Permanent Aviation Fuel Facility Overview of Issues relating to Hazard Assessment

Comparison of Assumptions and Basis of Hazard Assessment in the PAFF EIA Report and Public Comment PA#01323 (HSL)

This note addresses the assumptions used and basis adopted for the hazard assessment conducted by the Airport Authority Hong Kong as compared with those used and adopted by other different parties contained in the public comments on the EIA report; specifically Comment PA#01323 (HSL) [1].

Environmental Impact Assessment Report on Permanent Aviation Fuel Facility for Hong Kong International Airport

Figure 1: Comparison of EIA and HSL Total Societal Risk Estimates for PAFF¹

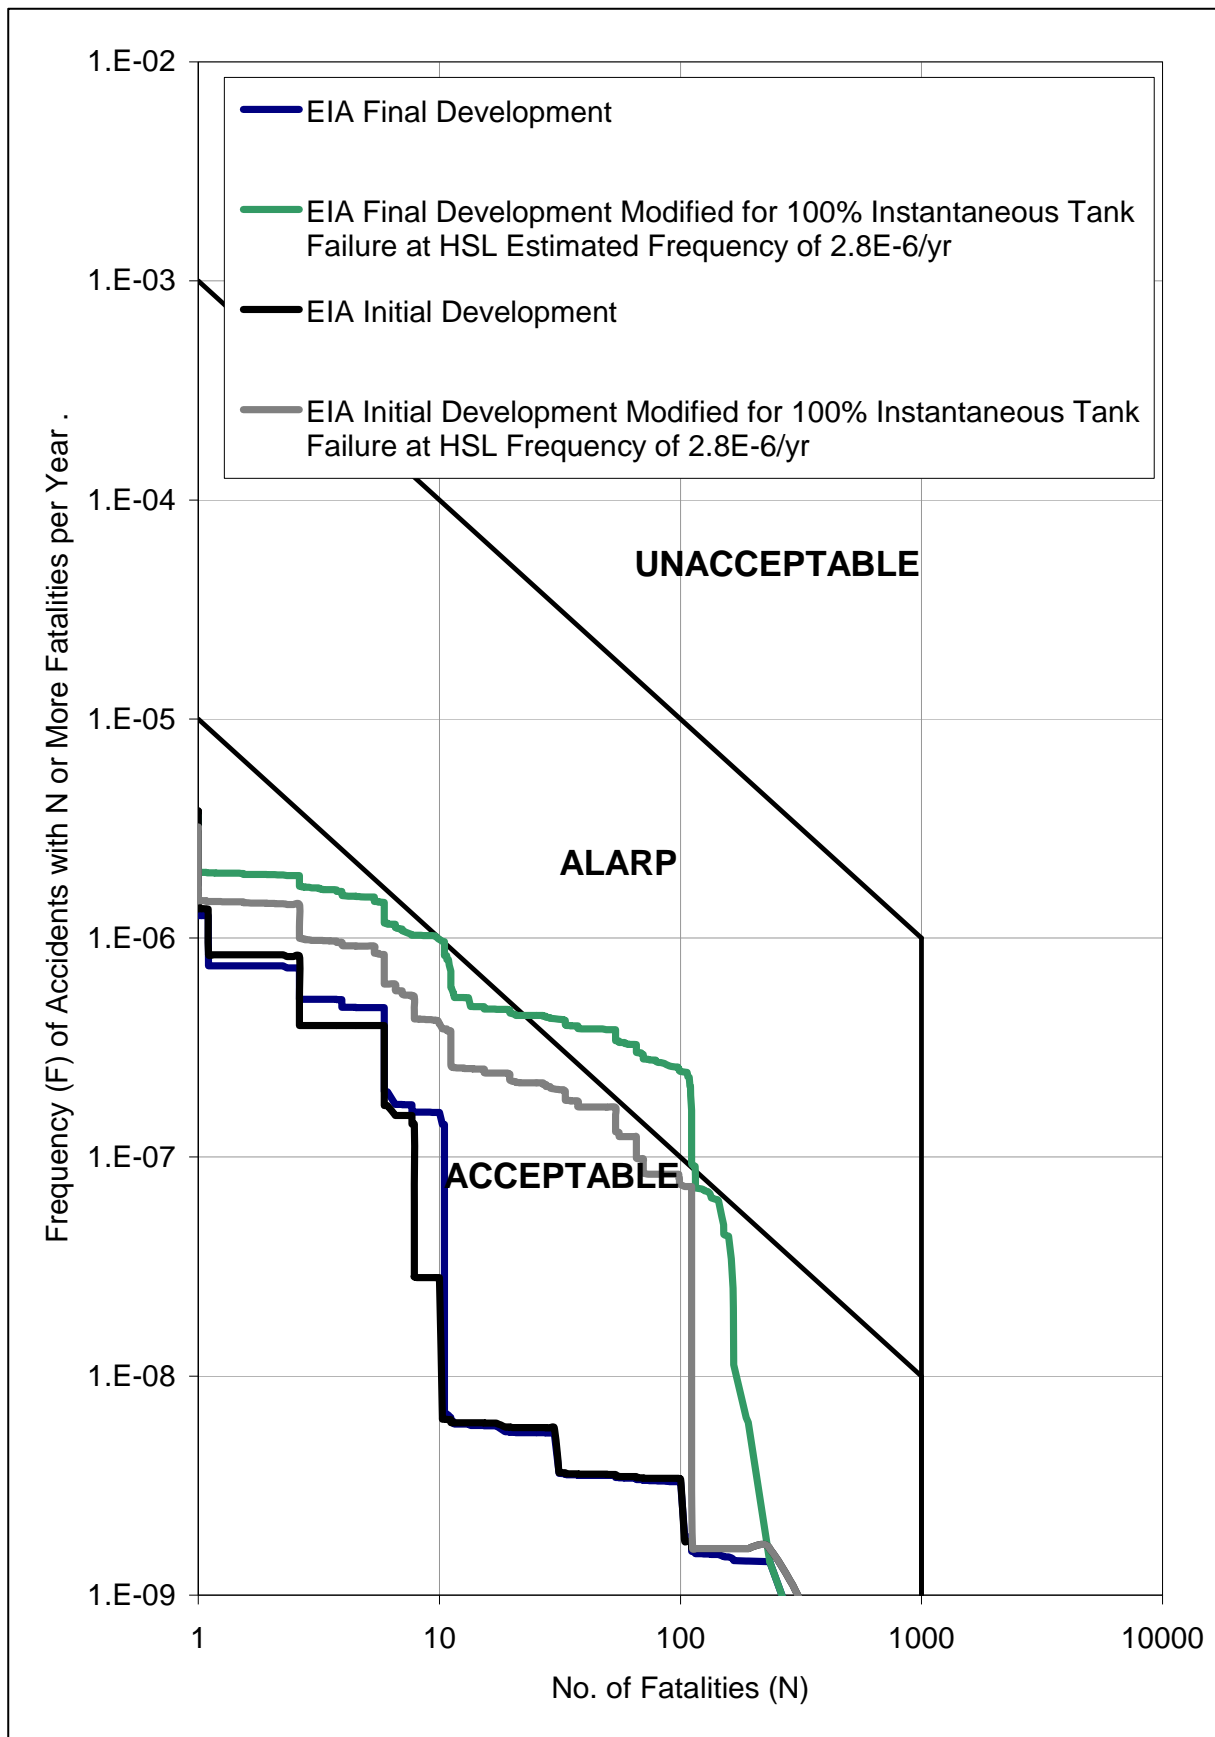
For the sake of argument, even if HSL's 100% instantaneous tank failure frequency of 2.8×10^{-6} /yr is used (Figure 1), the Initial Development is completely acceptable and the Final Development (beyond year 2025) is also acceptable, providing the risks for the Final Development are kept As Low As Reasonably Practicable¹.

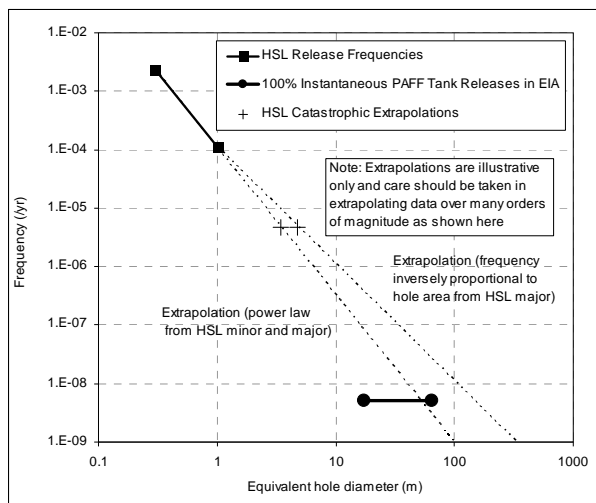
The effects of the extrapolations of data are shown in the adjacent figure using the power law derived directly from the HSL [9] minor and major release sizes and frequencies and also by assuming the frequency is inversely proportional to hole area. Within these limits, the hole size one might assume for the HSL catastrophic failure frequency of 4.8×10^{-6} /yr is 3-5m (~10-20 m²). Whilst such failures are “catastrophic” they are much smaller than the 100% instantaneous failure sizes for the PAFF tanks. Compared to these extrapolations from Glossop’s figures, the frequencies used for the size of release required for a 100% instantaneous failure of a PAFF tank are realistic (rather than optimistic as asserted by HSL [1]). However, one should always be cautious with extrapolating data, particularly when the data is very limited and the extrapolation is over many orders of magnitude. The main point to note is that the frequencies for “catastrophic” failure and “100% instantaneous failure” should be different because the definitions of the incidents are different; HSL [1] have not allowed for this.

The HSL analysis [1], therefore introduces a potentially very large degree of pessimism by treating all catastrophic (>1m equivalent diameter) failures as equivalent to 100% instantaneous releases.

Figure 2: Comparison of EIA and HSL Societal Risk Estimates For Initial PAFF Development

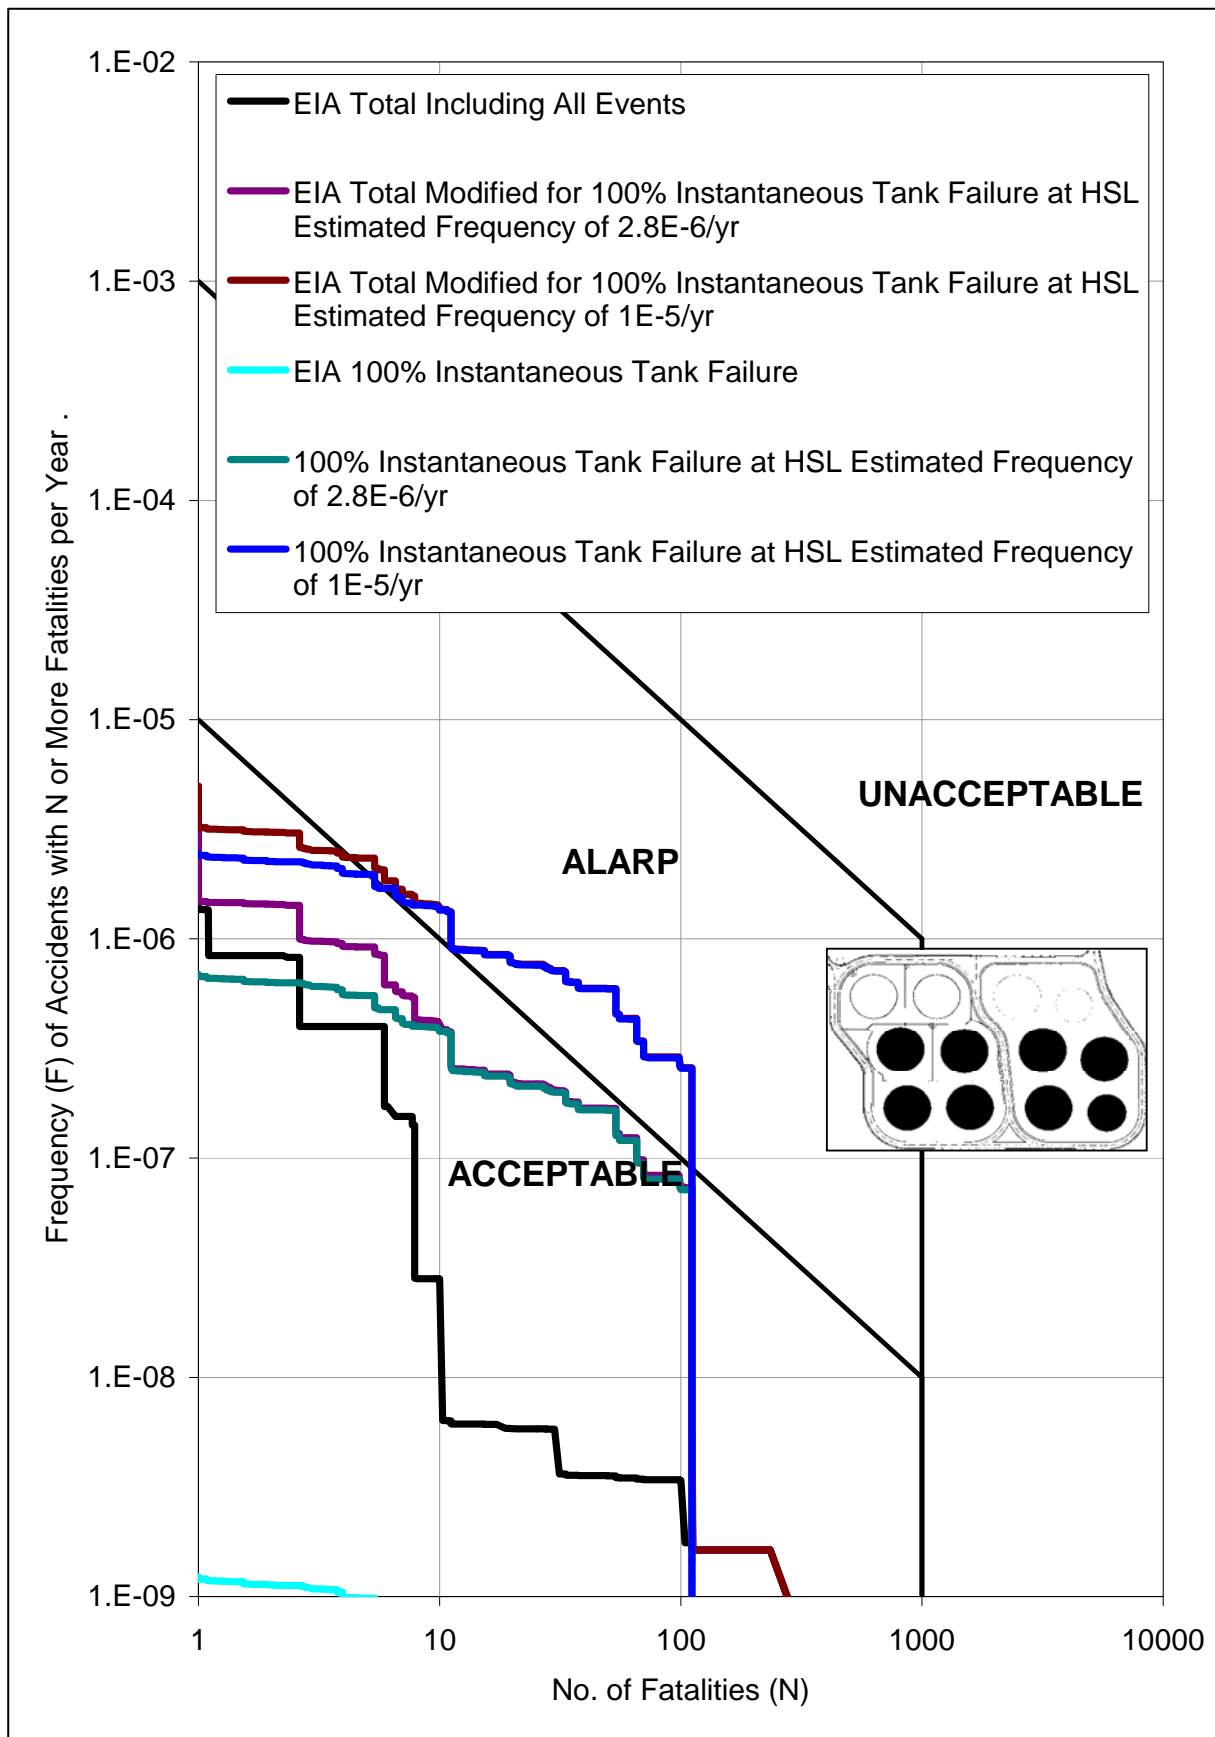
Figure 2 shows a comparison of the results from the EIA with those modified for HSL’s [1] suggested 100% instantaneous tank failure frequencies for the Initial Development (8 tanks) and Figure 3 shows the same information for the Final Development (12 tanks). The basis is the same as shown in HSL’s comments [1]
